**ADDENDUM NO. 2**  
**13 September 2013**

TOWN OF ACTON  
GENERATOR UPGRADE AT DISTRICT ONE & TWO FIRE STATIONS  
Acton, Massachusetts

TOWN OF ACTON  
472 Main Street  
Acton, MA 01720  
978-929-7744

Reference Contract Documents (drawings and specifications) dated 29 August 2013.

**SKE-1**

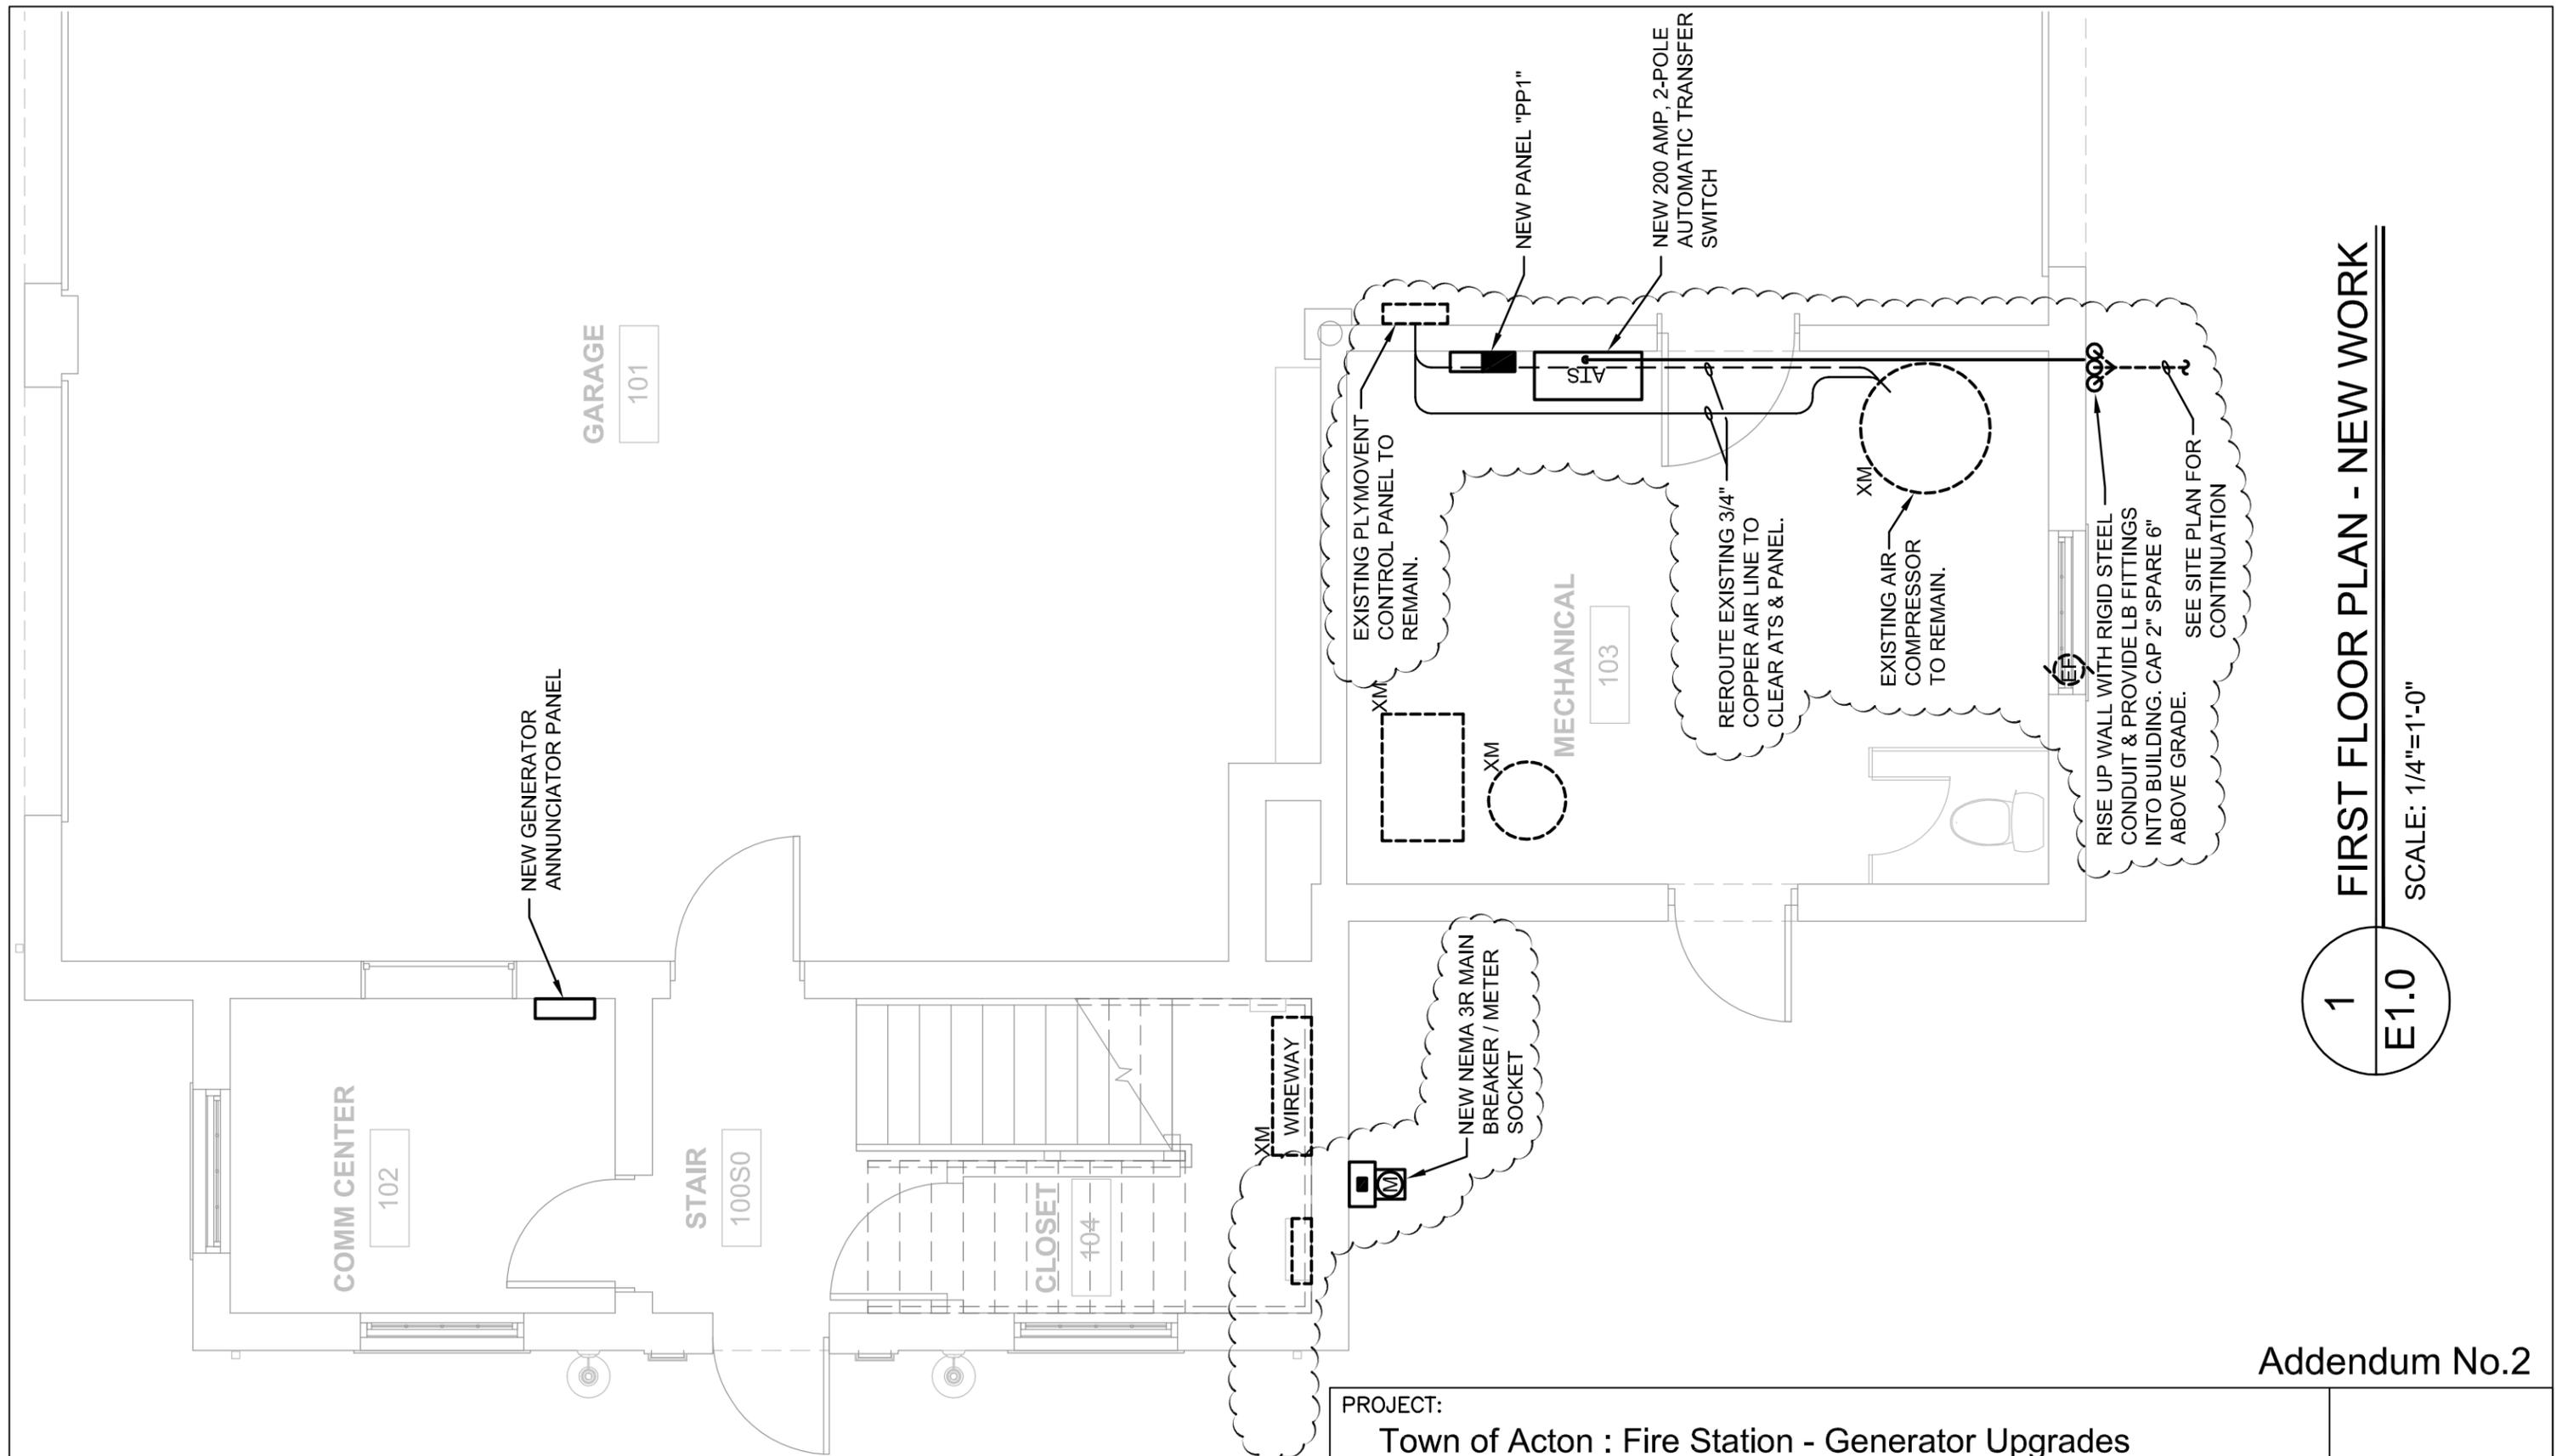
Item 3. E1.2 - ELECTRICAL FLOOR PLAN & SITE DETAILS

- Detail 1/E1.0 – Existing exterior blank meter socket shall be labeled "X" & indicated to be removed, in lieu of "XM" & to remain.
- Existing interior utility co. meter socket shall be labeled "X" & indicated to be removed, in lieu of "XM" & to remain.
- Note for existing exhaust fan shall be changed to "to be disconnected & left in place", in lieu of "to be removed. Seal & weatherproof opening."
- Incorporate the clarifications and/or revisions on the following sketch: SKE-1.

SKE-2

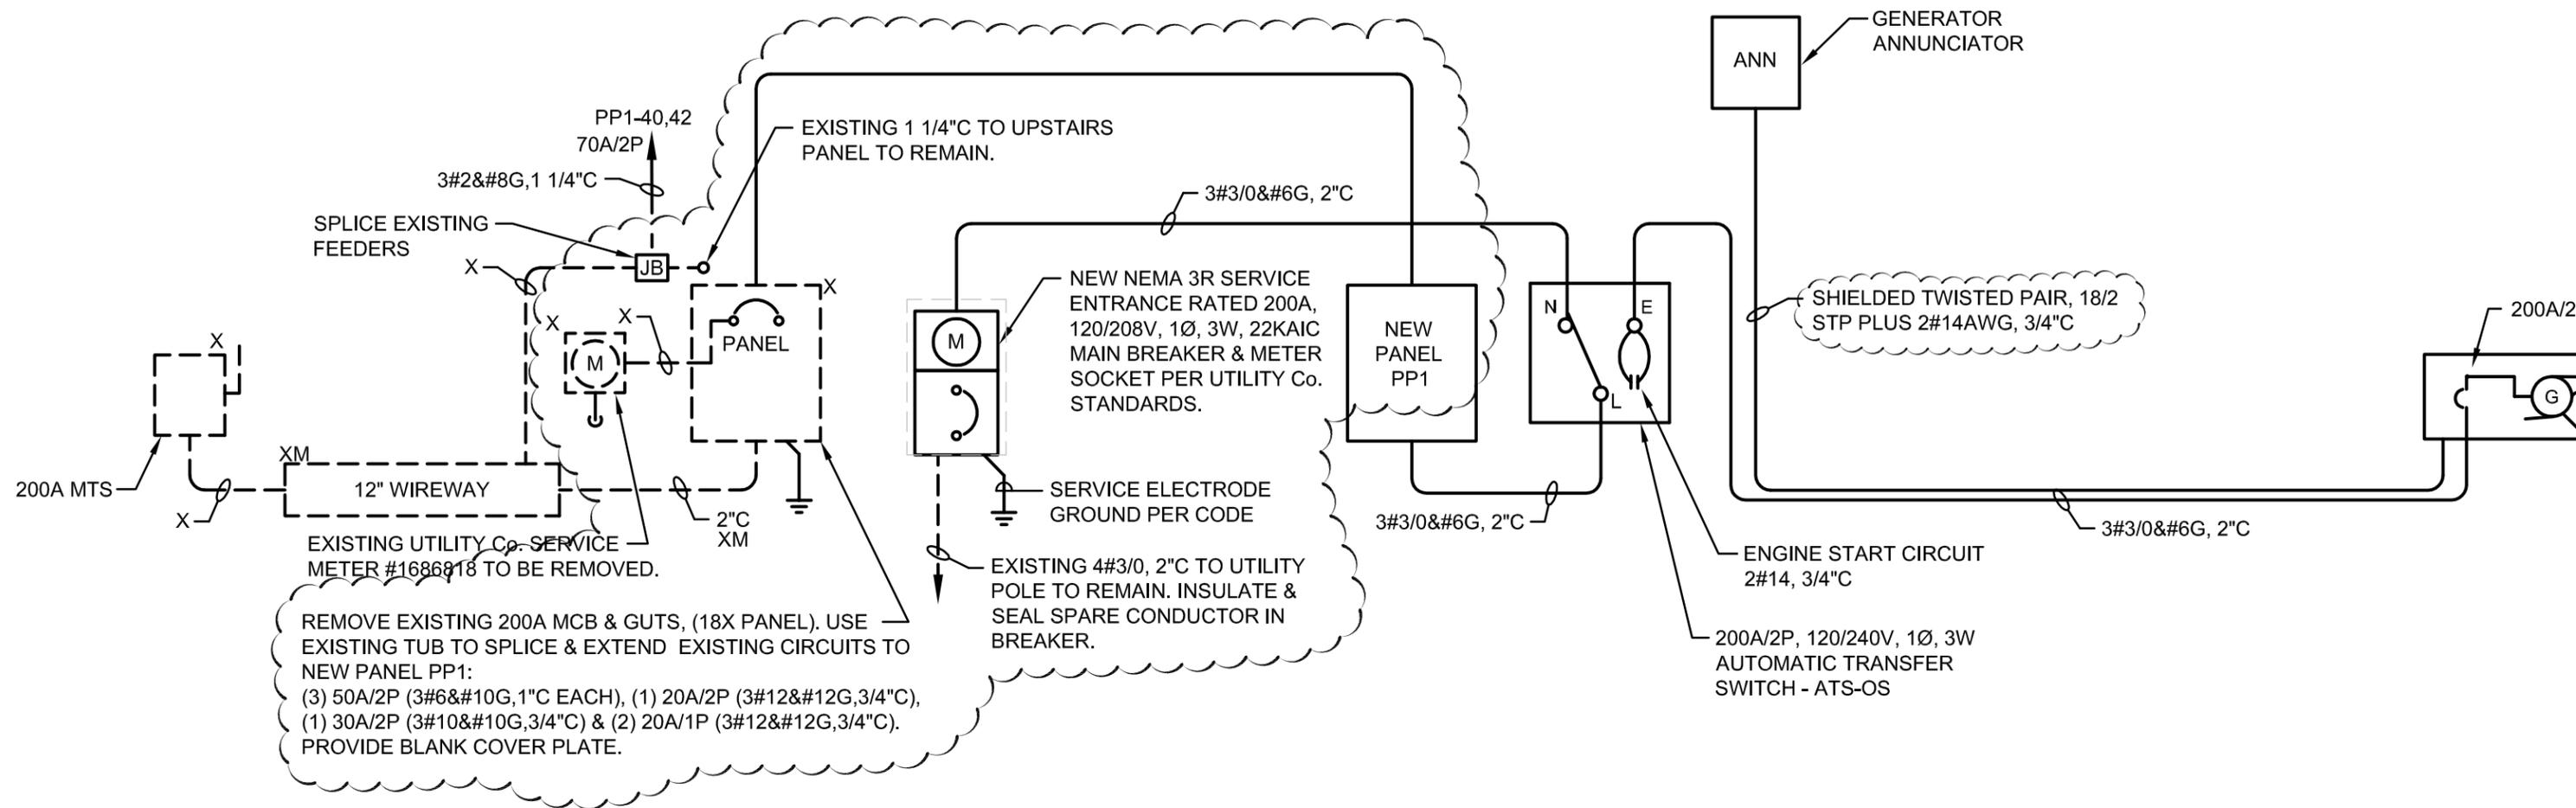
Item 4. E1.3 - ONE LINE POWER RISER & DETAILS

- Detail 5/E2.3 - Feed between generator remote annunciator & generator control panel shall be changed to "shielded twisted pair, 18/2 STP plus 2#14awg, 3/4"C, in lieu of 21#14-1"C.
- Incorporate the clarifications and/or revisions on the following sketch: SKE-2.

**SKE-4**

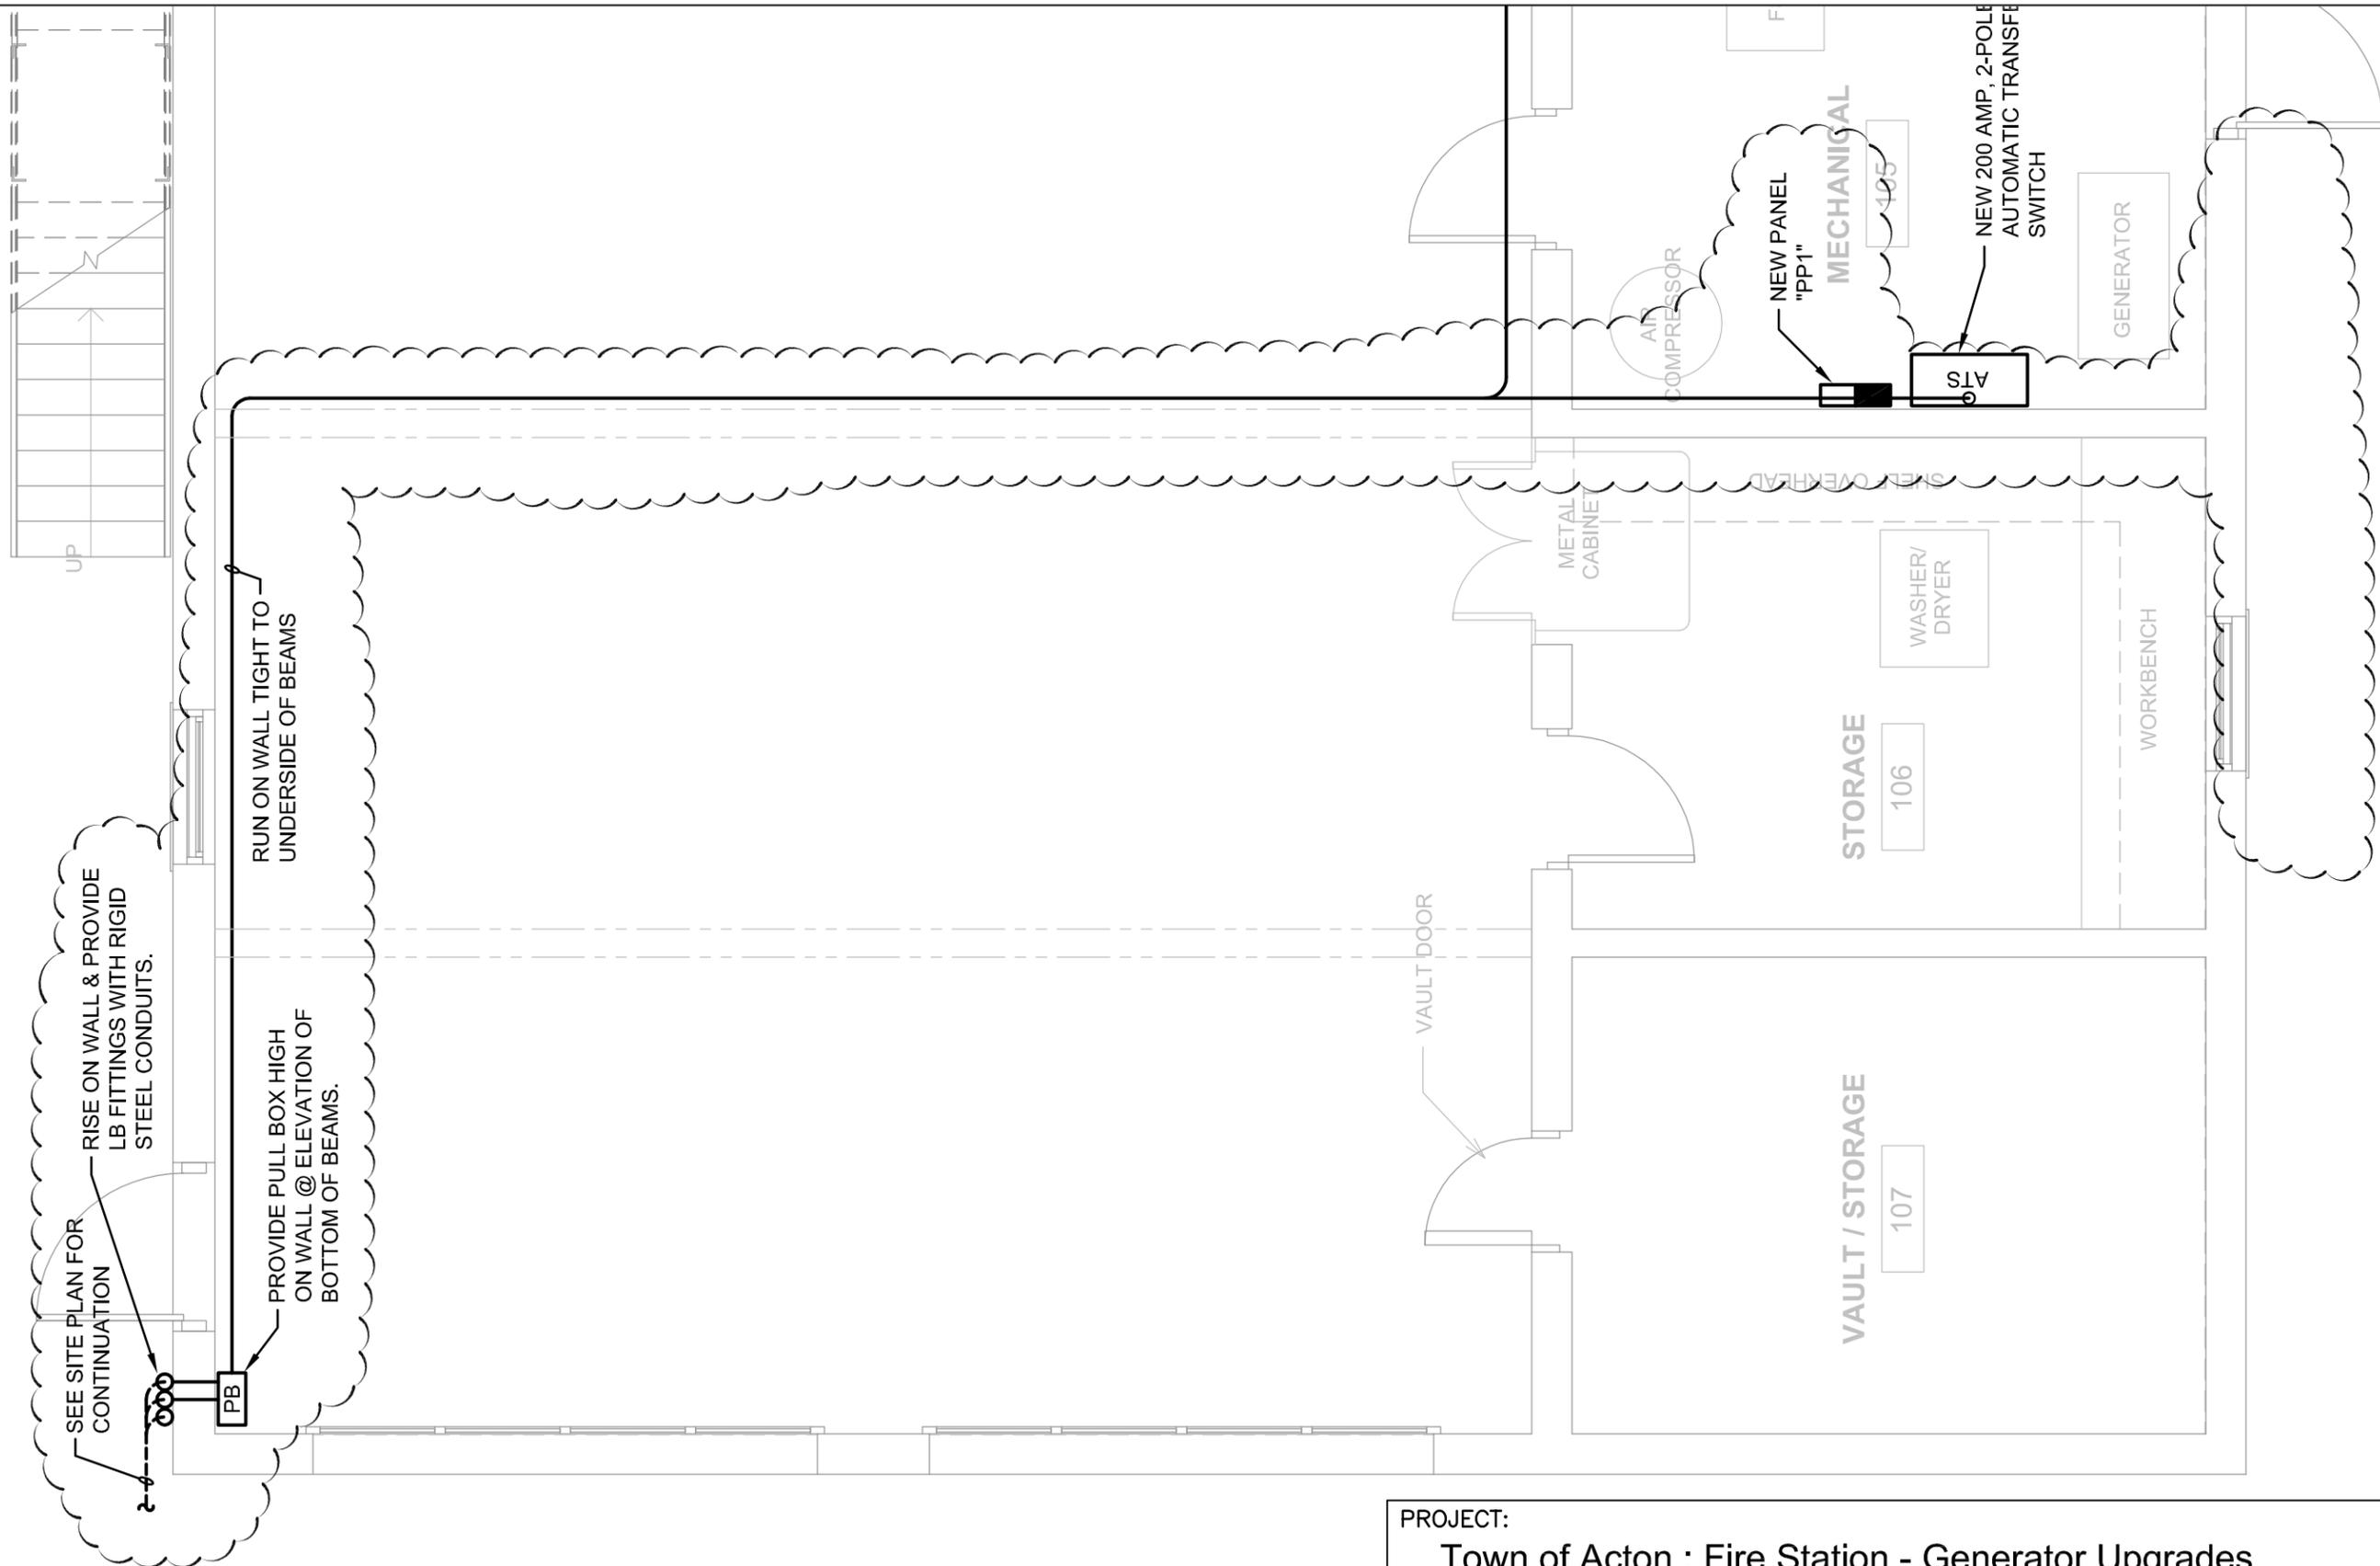
Item 6. E2.2 - ELECTRICAL FLOOR PLAN & SITE DETAILS

- Detail 1 shall be labeled 1/E2.2, in lieu of 1/E1.0 indicated.
- Detail 2 shall be labeled 2/E2.2, in lieu of 2/E1.0 indicated.
- The (2) existing panel boards ("PP1" & "PP2") shall be tagged "X" (to be removed), see riser.
- Conduit for annunciator panel feed shall be changed to 3/4"C, in lieu of 1"C.
- Incorporate the clarifications and/or revisions on the following sketch: SKE-4.
